**From:** Lasley, Timothy G  
**Sent:** Wednesday, May 23, 2018 11:37 AM  
**To:** 'julia@dinsmorehouse.com'  
**Cc:** Werner, Jeffrey B; Mess, Camie  
**Subject:** BAR Actions - May 15, 2018 - 1121 West Main Street

BAR 16-06-04  
1211 West Main Street (Dinsmore House Inn)  
Tax Parcel 100059000  
1817 House LLC, Owner/Ryan Hubbard, Applicant  
Landscape Plan Modifications

**CITY OF CHARLOTTESVILLE  
BOARD OF ARCHITECTURAL REVIEW  
STAFF REPORT  
May 15, 2018**

Landscape Plan Modifications Submittal - April 2018

**LANDSCAPE PLAN**

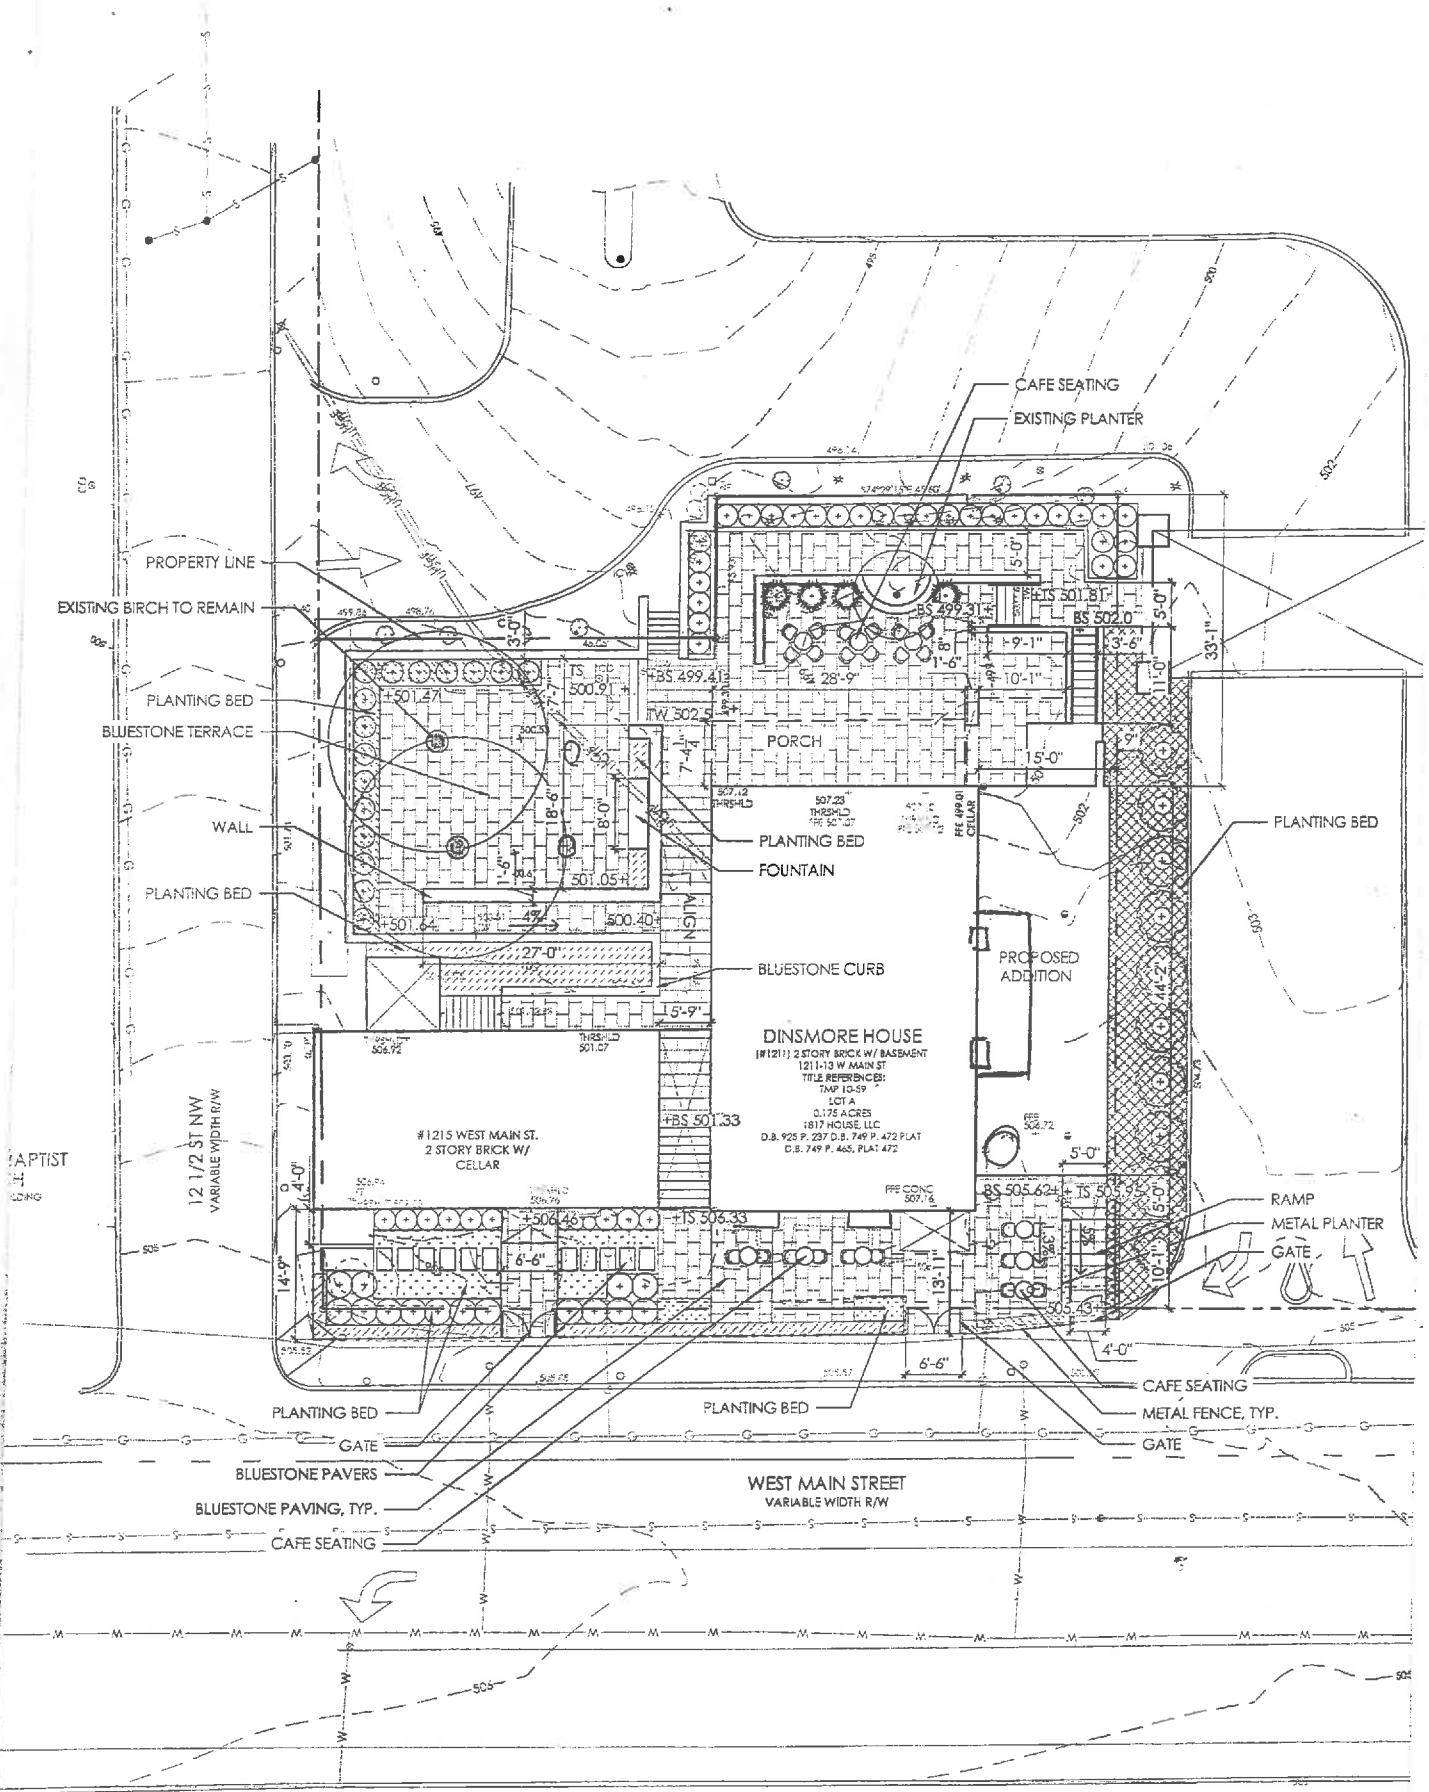
**Motion: Schwarz moved: Having considered the standards set forth within the City Code, including City Design Guidelines for Site Design and Elements, I move to find that the proposed landscape plan modifications satisfy the BAR's criteria and are compatible with this property and other properties in the West Main Street ADC district, and that the BAR approves the application as submitted. Sarafin seconded. Approved (6-0).**

The BAR should discuss if these plantings are adequate substitutions to what was originally approved in the Certificate of Appropriateness and if the landscape modifications are appropriate within this district.
